42-44 VERMONT AVENUE

Memorandum from Department of Building Inspection, Portland, Maine

AP 42 Vermont Ave. --Demolishing existing rear piazza and constructing new addition--

42-44 Vermont Ave.- New Garage for Earl E. Banc ---6/18/42

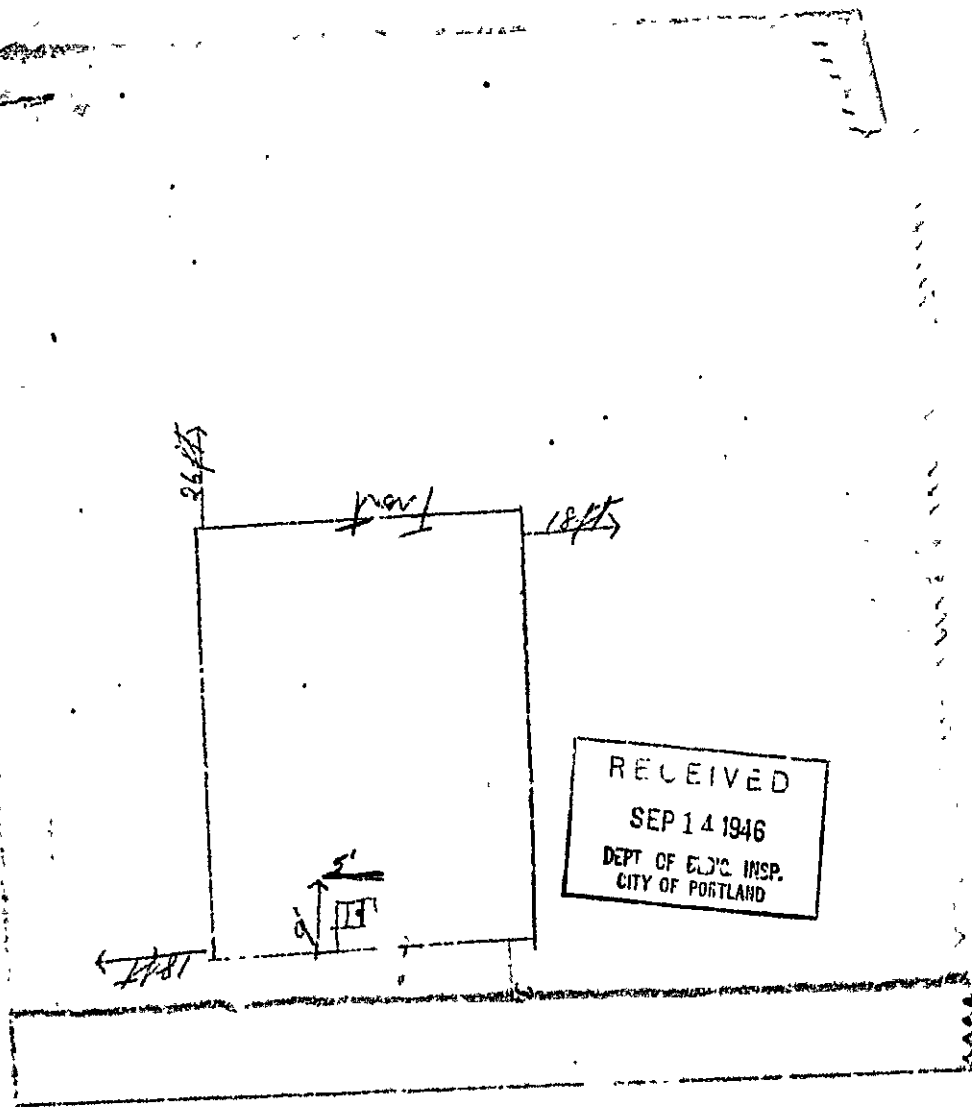
Note 4x6 sill is to be set with 6" dimension upright, supported either on top of sill or notched over no less than 2x3 nailing strip spiked to side of sill--not "tee-nailed".

Note requirement for notice, inspection, and approval before any part of inside of walls or any part of ceiling is covered from view.

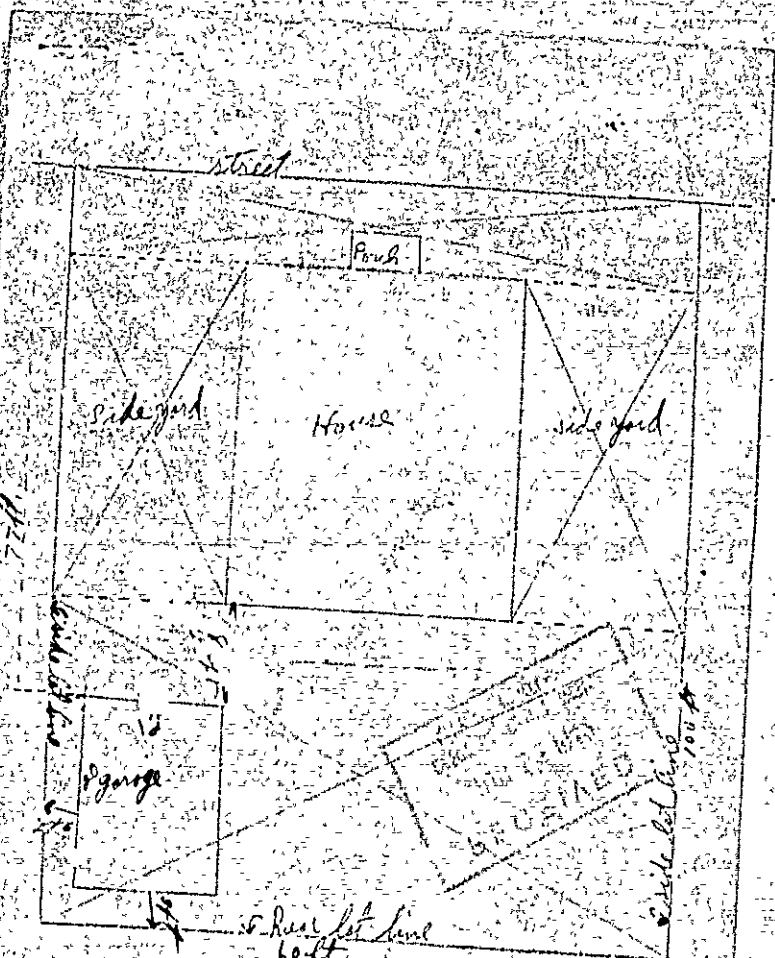
sills 4x6
 2 girders 4x6 flat on posts floor to the over yard and sills
 6 in. gaps 4 in. a yard
 corner posts 4 in
 Posts 2x4 - 2 in spacing
 Roof 1/2 pitch
 asphalt Hays on shingles on roof
 Posts under sills 5 ft. space on sides and in 6 ft
 ft on ends.

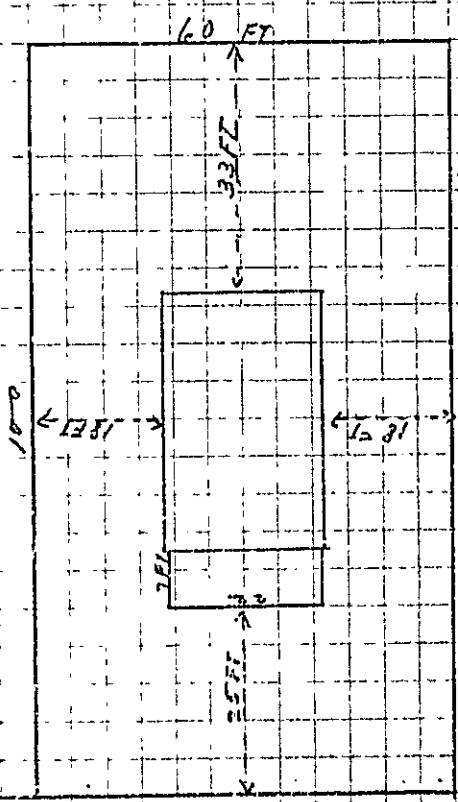
Application and sketch seem somewhat at variance. Application says dirt floor, but note on sketch seems to indicate wood floor as follows: " 2 girders 4"x5" flat on posts floor to be over girder and sills-6 in. posts 4 to a girder."

Permit is issued on basis of a ~~wood~~ dirt floor. No reason why you cannot have a wood floor if you want it, but if you do the framing ought to be straightened out. If you lay the girders with the 4-inch dimension upright (indicated by word "flat") you will not get nearly as much strength as though you set it with the 6-inch dimension upright. The same applies to the sills.
